THE MARYLAND-NATIONAL CAPITAL PARK AND PLANNING COMMISSION

MEMORANDUM

Glen Echo Heights

1-03094

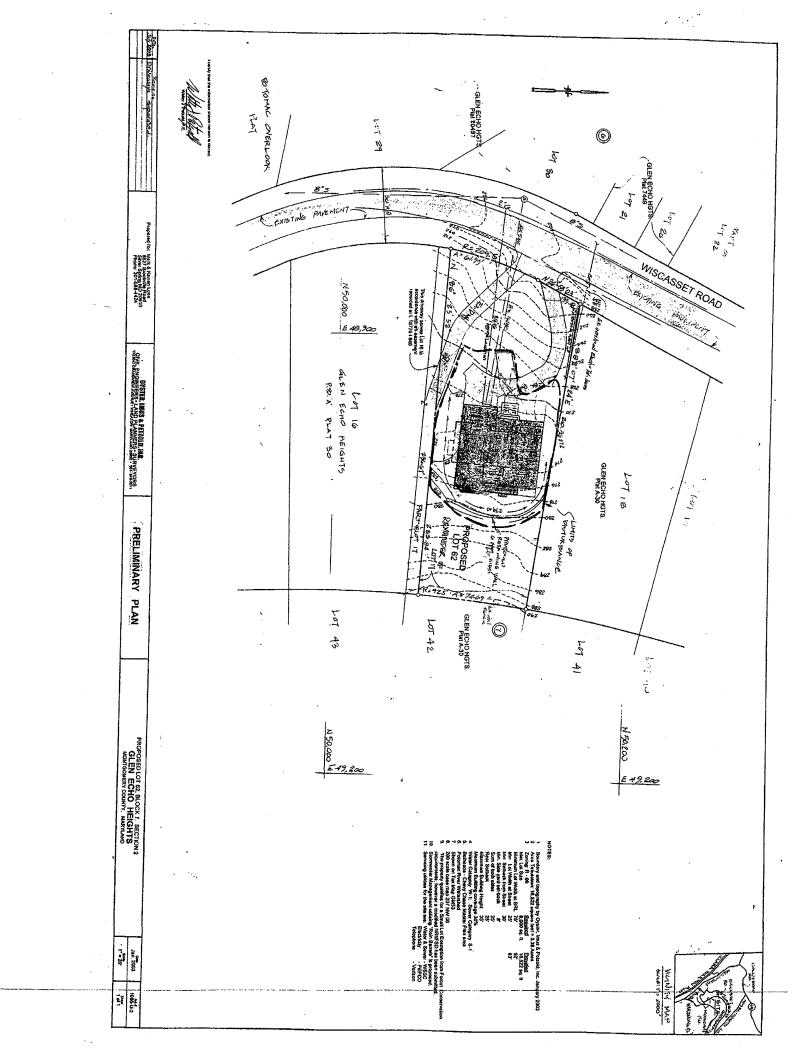
However, we would like to take this opportunity to express our concern that the owner/developer of proposed Lot 62 make every effort in the final building plans to preserve as many of the older, mature trees as possible, particularly a number of substantial Oak trees which are located near the upper driveway of the current house. We are particularly concerned with protecting the large Oak, which is located near the boundary with Lot 16 in the vicinity of the proposed garage entrance to the new house, as shown on the preliminary plan.

Thank you for providing our community association the opportunity to comment on the above referenced project. It appears that the project structure would encompass a substantial amount of the lot, and that the retaining wall detailed in the plan would extend all the way to the adjoining lot boundaries. Such intense land use in a building lot would disturb the nature of the community.

Given these facts, this project should be scaled back so the project does not so overwhelm the lot.
